Ref:jhh:High level review for Metro

**RE: High level review of vibration and regenerated noise assessment for the Melbourne Metro**

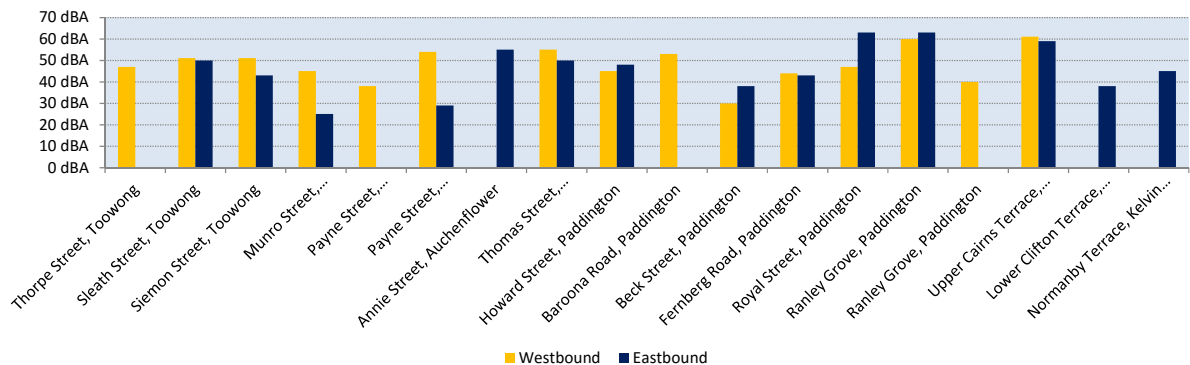
developments. The report did not indicate the average number of nights each household was relocated for. The following graph shows the measured levels of regenerated noise at sections along the tunnel alignment.
